Figure 11: Ground floor layout of walk-up flat building (Source: Urbis)

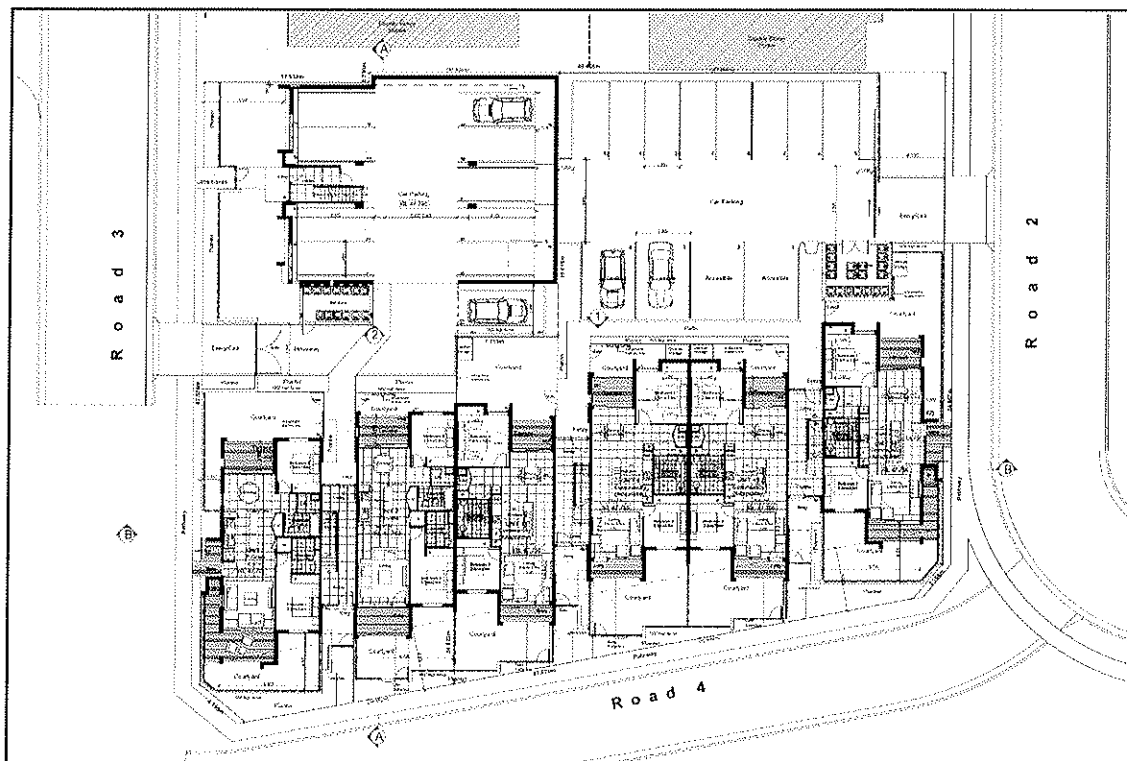
In principle, Council do not object to the introduction of walk-up flats as they agree that the proposed modification is an improvement on the larger "plex-style" dwelling buildings originally approved in the Concept Plan and performance measures proposed for walk-up flats will ensure that a high level of amenity and quality of built form is achieved. However, Council raised concern that the walk-up flats may increase crime and also requested that a lift be provided within each building.

The Proponent argues that lifts are an unnecessary expense and will reduce the affordability of apartments. The ground floor of the walk-up flat building provides 6 x 2 – bed units at ground floor level, all of which are designed to be adaptable-living dwellings which is more than adequate to cater for older or disabled owner/occupiers or tenants. Four of the 6 units will be under SGCH management.

In addition, the Department is satisfied that safety and crime concerns raised by Council will be adequately addressed in the design and future management of the walk-up flat building.

The provision of lifts within walk up flats is not considered necessary given compliance with SEPP 65 will ensure suitable levels of amenity are achieved with regards to access to the site. In this regard, it is considered the introduction of three storey walk up flats into the development is supported.
